Docket Item #5
DEVELOPMENT SITE PLAN #2004-0018
Beauregard / Armistead Towns

Planning Commission Meeting
January 6, 2005

ISSUE: Consideration of a request for a development site plan, for construction of a 42-unit "townhouse-style" condominium development.

LOCATION: 520 North Armistead Street

Cross Section Showing Extent of Proposed Grading

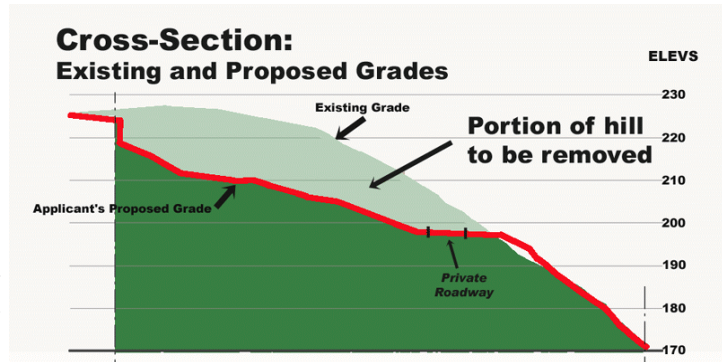
The combination of the proposed building heights, grading, and setbacks will cause the proposed townhouses to tower over Beauregard Street. The limits of grading, which come within 20 ft. of Beauregard Street, will leave few existing trees to provide a buffer from those townhouses. Little of the existing grade or trees will be retained, as the applicant is proposing to grade 85% of the site. Such a limited amount of open space on the site is usable or functional, as approximately 85% of the

In order to attain compliance, staff is recommending eliminating four units (required in any event to comply with the RA zone’s open and usable space requirement) and shifting the remaining units 19 ft. farther from Beauregard to create a minimum 55 ft. setback and buffer from Beauregard Street. The applicant contends that there are other buildings as close to Beauregard as they are proposing. However, these buildings are generally lower scale buildings and are not elevated by the topography of the site as proposed by the applicant. In addition, most of the mature vegetation that would otherwise screen that building will be lost during construction. While most of the trees that are on the site are generally not large trees (6-24" caliper trees), collectively the trees create a dense tree canopy for the site and Beauregard. The development as proposed will eliminate much of this wooded area, as it requires the grading of approximately 85% of the property and will result in the loss of at least three-quarters of the trees that have a caliper size of 6" or greater. The degree of change from pre-development to post-development conditions is unnecessary to reasonable development of the site and will be dramatic. The adverse impact of an inadequate buffer will be exacerbated by the topography of this proposed development, as the buildings will be substantially elevated above the street grade.

Most of the required setbacks within the Zoning Ordinance include a setback ratio, which requires greater setbacks for taller buildings. This approach is also consistent with the recently completed Ashton Manor development, where the buildings have a setback ratio of greater than 2 to 1 and where the buildings are setback 72 to 88 ft. from the Beauregard roadway. Staff is recommending

that this application provide a setback that is closer to that which has been provided by recent developments in the corridor and will be consistent with the Open Space Plan, which lists Beauregard Street as a tree-lined boulevard which is to be protected and enhanced. This increased buffer, particularly at the intersection of Beauregard and Armistead Streets, will increase the number of trees that can be retained. These changes are the minimum buffer enhancements required to comply with Zoning Ordinance Sections 11-410(C), (F) and (W).
